Model: See Affected Product Line Serial #: N/A	Aug. 6, 2026
Product Bulletin # TDS-281 Rev 1

Release of New Steel Stabbing Bell Series

Figure 1: Top drive stabbing bell

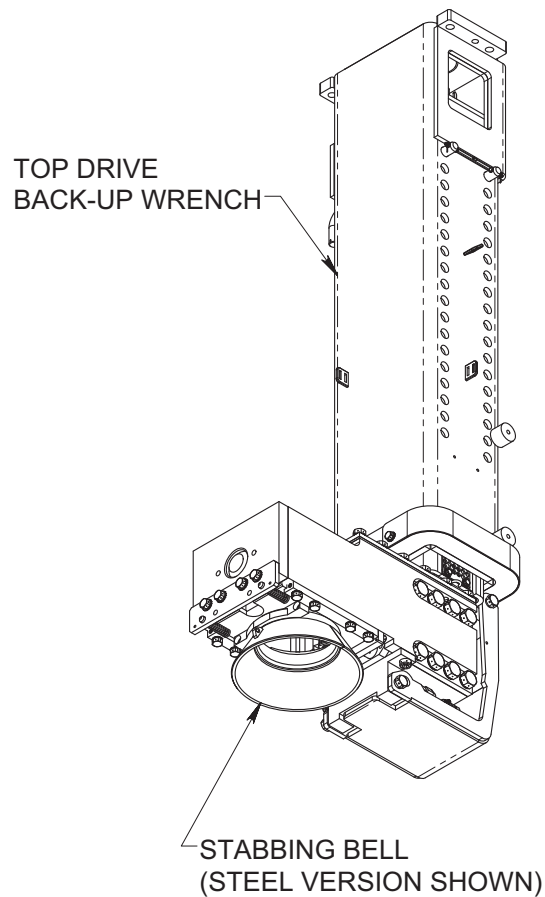
In order to consolidate the number of stabbing bell sizes that are offered, Canrig has released a series of new stabbing bells that should be compatible with all standard drill pipe sizes. Canrig is also releasing new recommendations for the proper sizing of stabbing bells based on the tool joint OD of the drill pipe being used, as oversized stabbing bells may contribute to difficulties with stabbing the pin of the LWCV (Lower Well Control Valve) or saver sub into the box of the drill pipe when making up connections.

To ensure effective stabbing of drill pipe into the BUW and onto the pin of the LWCV or saver sub, Canrig recommends using a stabbing bell with ID between 5/8" and 1" larger than the drill pipe **tool joint OD**. Select the appropriate stabbing bell size to use from Table 1 below based on the drill pipe **tool joint OD**.

All older steel stabbing bell part numbers are being phased out. Only those listed in Table 1 above will be available for purchase moving forward.
